PRECAST DRAWING COMPARISON REPORT

Complete Drawing vs Incomplete Drawing | Dimension Check

Project: Paisley Tower | Project No: P22-132 | Piece Mark: W10-78 | Stubbe's Precast

3B. Incomplete Drawing (Check Karni Hai)

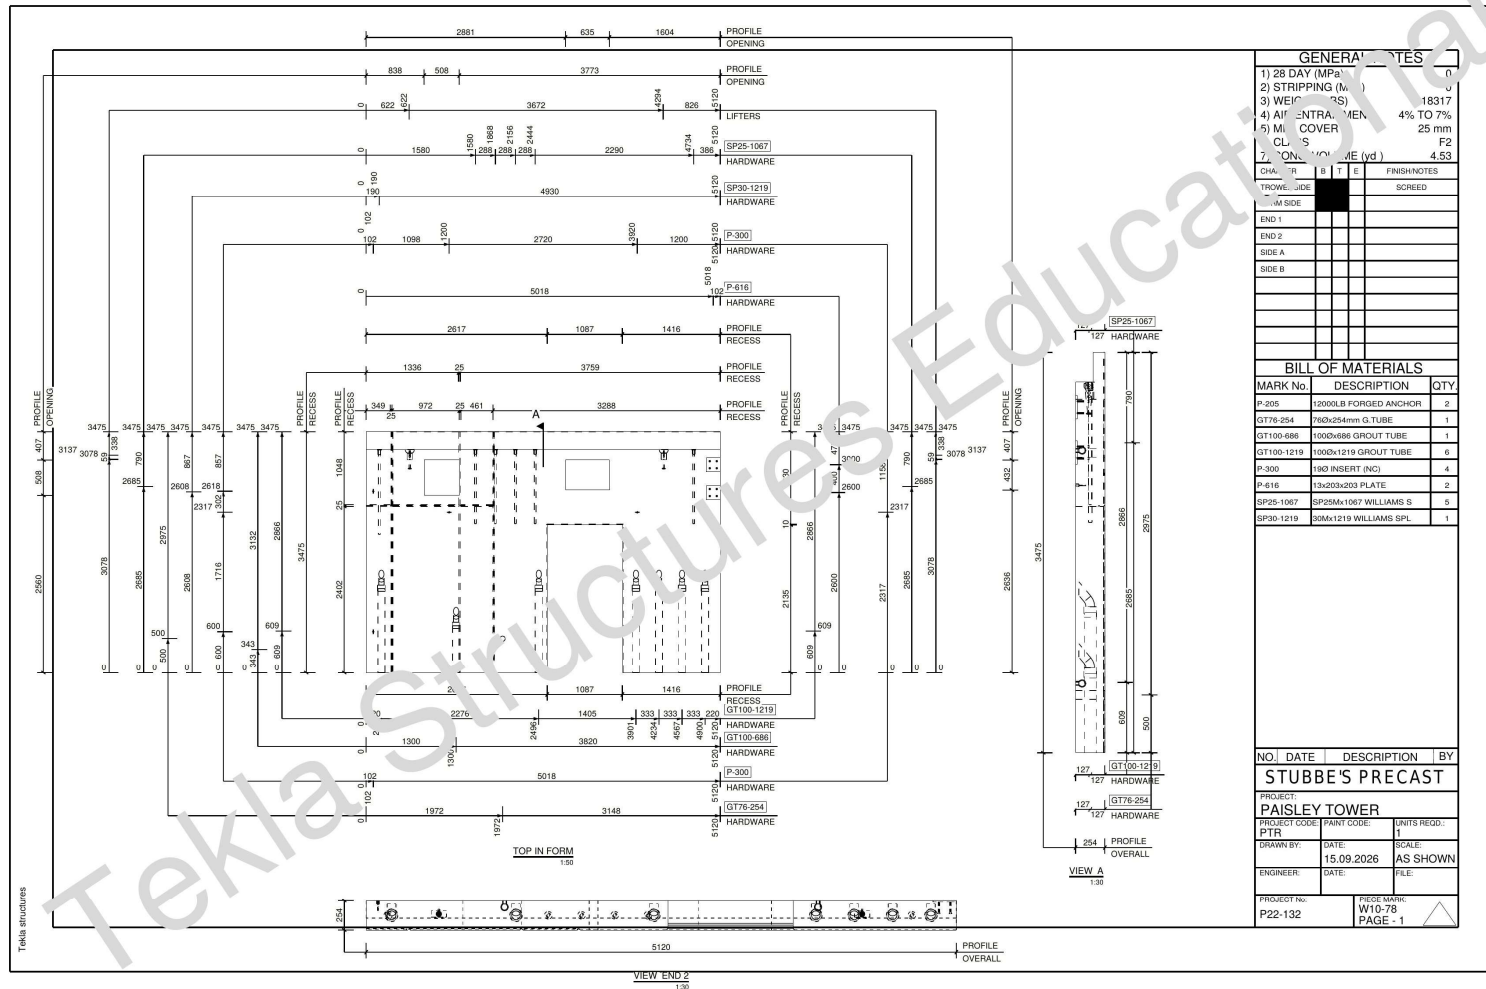
#	Component	Difference kya hai	Type
1	Lifters (P-205)	Drawing mein 6th number (position) par hai, lekin dimension galat hai.	Wrong Dimension
2	SP30-1219	Dimension sahi hai, lekin position galat hai.	Wrong Position
3	SP25-1067	Dimension sahi hai, lekin position galat hai. (Row number 7th se 8th change hua hai.)	Wrong Position
4	P-300	Hardware mein extra cuts hain. Bracing Insert aur Hardware dono mix ho gaye hain (alag-alag hone chahiye).	Extra / Mixed
5	P-616	Dimension sahi hai, lekin position galat hai.	Wrong Position
6	TYP. V-Reveal	Drawing mein nahi hai.	Not in Drawing
7	Profile Opening	Drawing mein dimension galat hai.	Wrong Dimension
8	Profile Overall	Drawing mein nahi hai.	Not in Drawing
9	GT100-686	Position 2nd hai aur dimension bhi sahi hai.	Correct
10	GT100-1219	Position galat hai (1st), dimension sahi hai.	Wrong Position
11	GT76-254	Position galat hai (5th) aur dimension bhi galat hai.	Wrong Dim + Position

12	Profile Notch	Drawing mein nahi hai.	Not in Drawing
13	Vertical Dimensions	Extra dimensions add ho gaye hain jo nahi hone chahiye.	Extra Dimension

Recess chahiye hi nahi hai, isliye vertical dimension mein Recess likhna nahi hai. Check karein ki drawing mein Recess na likha ho.

13 main items mein se sirf 1 item (GT100-686) पूरी तरह sahi hai.

3 items drawing mein missing hain: TYP. V-Reveal, Profile Overall aur Profile Notch.

5 items ki position galat hai: SP30-1219, SP25-1067, P-616, GT100-1219 aur GT76-254.

3 items ka dimension galat hai: Lifters (P-205), Profile Opening aur GT76-254.

P-300 mein Bracing Insert aur Hardware mix ho gaye hain, aur vertical dimensions mein extra dimensions hain.
